**WHITE LAKE TOWNSHIP
ZONING BOARD OF APPEALS**

**REPORT OF THE
COMMUNITY DEVELOPMENT DEPARTMENT**

Agenda item: 8d

RE: Gateway Crossing
Preliminary Site Plan and Special Land Uses – Review #4

TITLE: EXISTING CONDITIONS & DEMOLITION PLAN

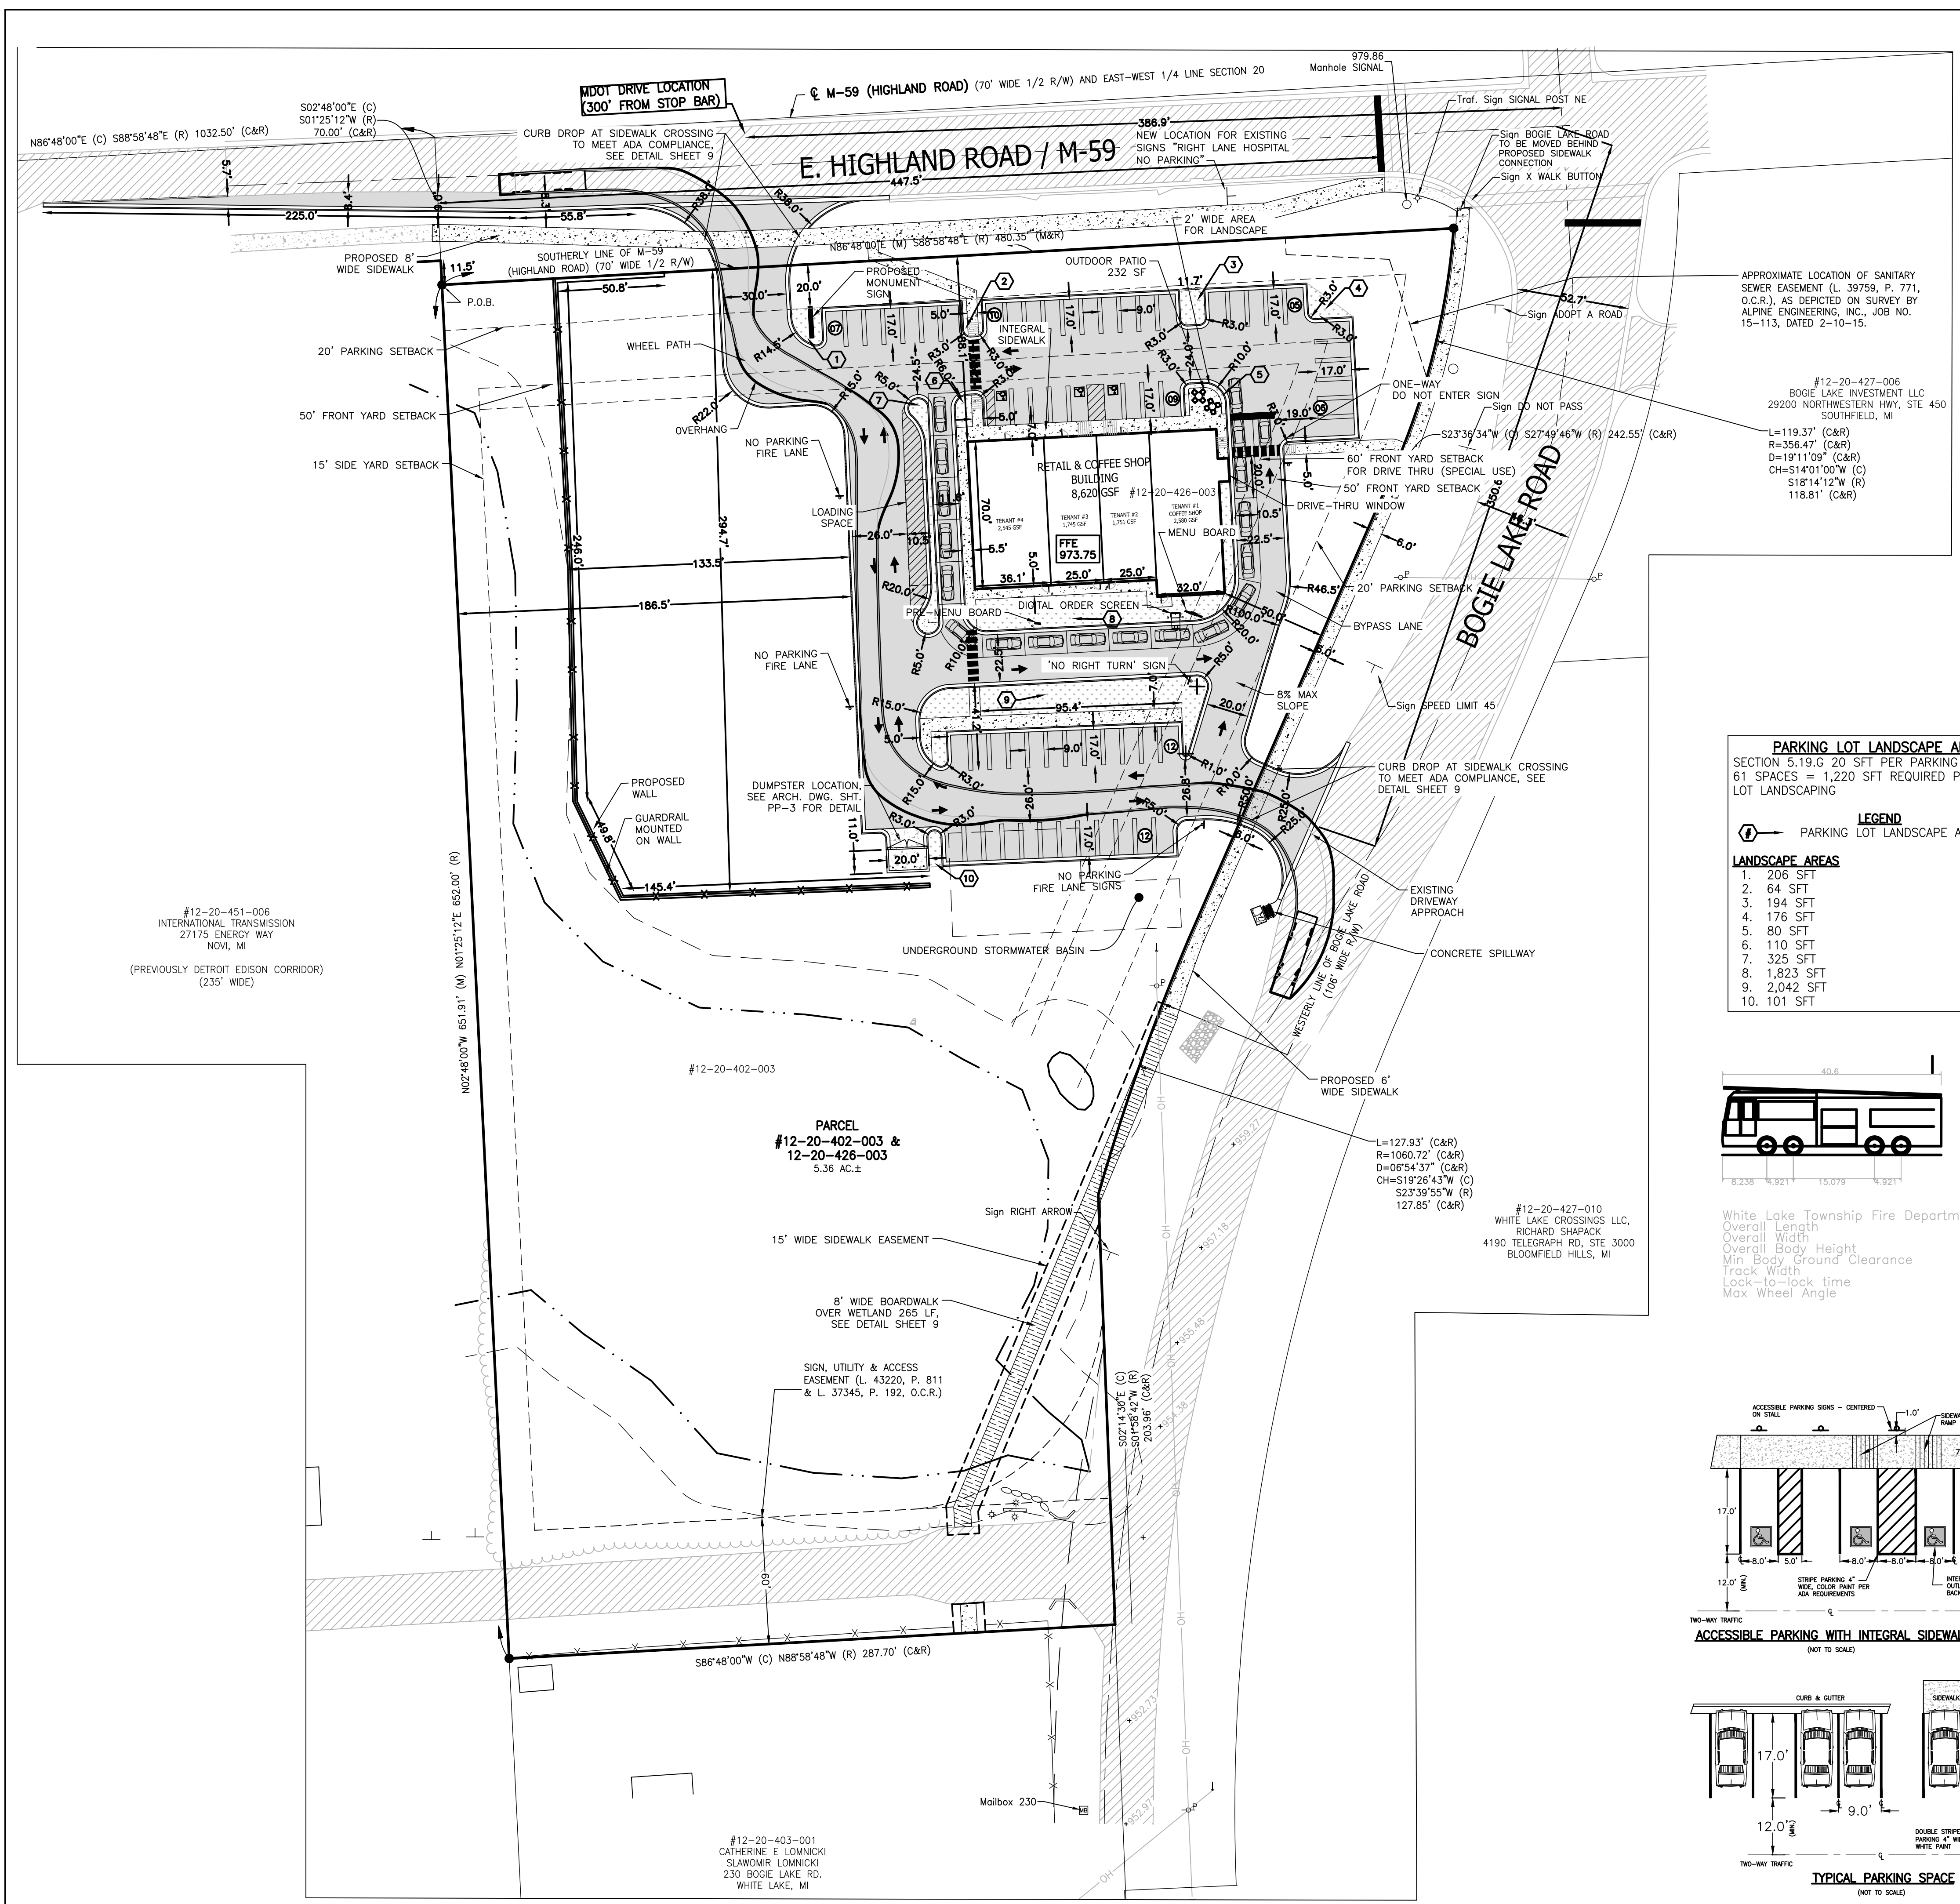
There appear to be EGLE (Michigan Department of Environment, Great Lakes, and Energy) regulated wetlands on the site. However, a wetland delineation was not provided. **A delineation prepared by a wetland specialist/ecologist must be provided by the Applicant at preliminary site plan.** (Comment outstanding. Provide a copy of a delineation report). (Comment addressed. A delineation report dated November 3, 2023 has been provided). EGLE has regulatory authority regarding the wetland boundary location(s) and jurisdictional status of wetlands on this site. **Prior to final site plan, wetland boundary verification shall be completed by EGLE. Note the proposed layout may require revision in response to the EGLE review. Based on the submitted plans, the Applicant proposes to grade within the Natural Features Setback. Grading activities should not occur in the Natural Features Setback as the intent is to, as much as possible, leave said area in its natural state. If grading is permitted to occur in the Natural Features Setback, the area must be restored to its natural, undisturbed state. A Natural Features Setback restoration plan is required and must be submitted at final site plan.** (Comments remain as notations. These requirements were acknowledged by the Applicant's engineer in the response letter provided to the first and second review).

SITE PLAN

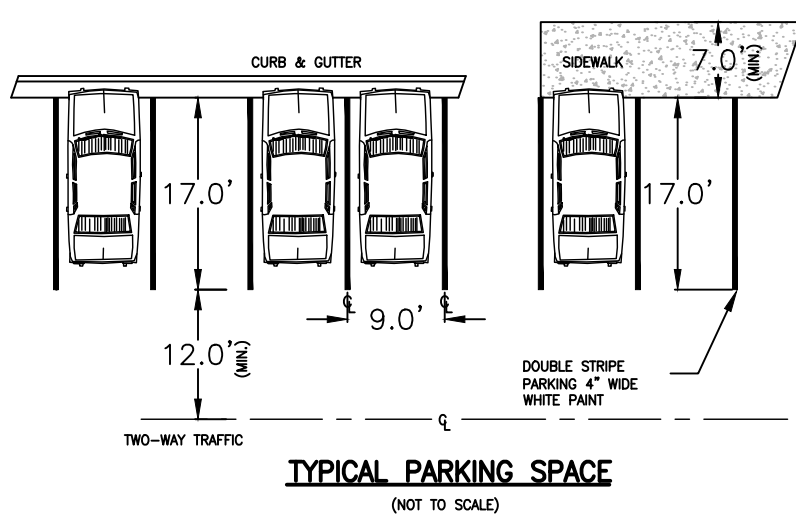
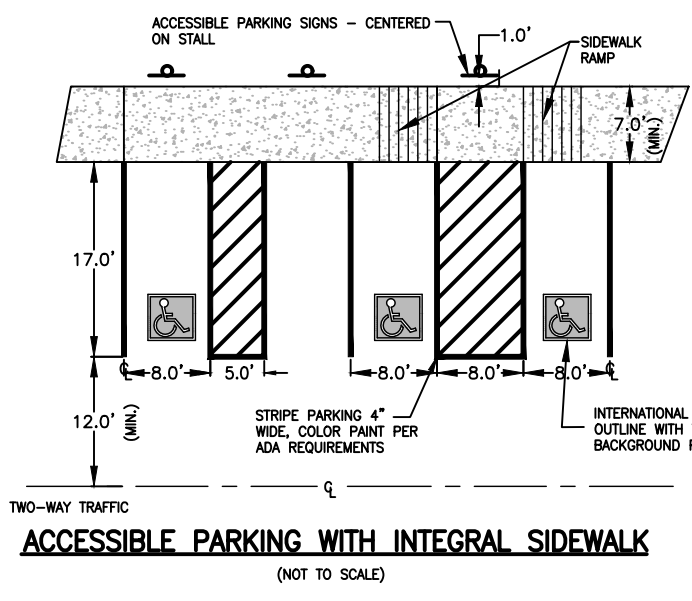
The development standards for the GB district require 50-foot front yard setbacks, 20-foot rear yard setbacks, and 15-foot side yard setbacks. **The proposed front (east) setback listed in the Site Data table on Sheet 3 is incorrect. Revise accordingly. (Comment addressed. The proposed east setback in the Site Data Table is now shown correctly). General Note 2 on Sheet 7 identifies the west setback as a front yard and not a side yard. Revise accordingly. (Comment addressed. The note has been revised).** The maximum building height allowed is 35 feet or two stories, whichever is less. Article 4, Section 17 of the zoning ordinance provides additional standards for drive-in or drive-thru window service, including a front yard setback of 60 feet (see Page 8 of this report regarding this requirement).

The parking calculations in the Site Data table on Sheet 3 are incorrect and shall be revised. (Comment outstanding. When units or measurements determining number of required parking spaces result in fractional space, any fraction up to and including one-half shall be disregarded and fractions over one-half shall require one parking space). (Comment addressed. Required parking calculations have been updated. See following comments). ~~54 parking spaces are required for Culver's, not 46. 31 parking spaces are required for the coffee shop, not 19.~~ The fast food standard shall be applied to the coffee shop. (Comment outstanding. Revise accordingly). (Comment addressed. Required parking calculations have been updated. See following comments). ~~Retail tenant space #1 requires 13 12 parking spaces, not 11 13. Retail tenant spaces #2 and #3 each require nine parking spaces, not seven. Additionally, gross floor area is utilized for fast food and retail uses, not useable floor area. It is unacceptable to remove 15 percent of the floor area from the parking calculations.~~ (Comment addressed). 116 65-77 parking spaces and 8 stacking spaces are required to serve the development and 90 48-61 parking spaces and 16 stacking spaces are proposed; therefore, a 26 17-16-parking space variance is required from the Zoning Board of Appeals. (Revise parking variance note on Sheet 3 accordingly). (Comment addressed. The applicable note on Sheet 4 has been updated).

Two-way drives are required to be a minimum of 24 feet in width. At the east end of the northerly drive aisle, the proposed width is 22.8 feet. Revise the site plan to increase the width to 24 feet; if not revised, a variance is required from the Zoning Board of Appeals. (Comment addressed. The aforementioned two-way drive aisle has been revised to be 24 feet in width).

The zoning ordinance requires each individual parking space be delineated by dual stripes, two feet apart centered on the dividing lines and painted white. Revise the site plan and the typical parking space detail on Sheet 3. If the required striping is not provided, a variance is required from the Zoning Board of Appeals. (Comment addressed. The plans as well as the parking space detail on Sheet 3 (now Sheet 4) now show white dual striping).

The typical parking space detail shows spaces 18 feet in length and the site plan shows the spaces 17 feet in length. Revise for consistency. (See previous comment. While the typical parking space detail shows parking spaces 17 feet in depth, the plan shows 18-foot-deep spaces in some areas). (Comment addressed. See previous comment).
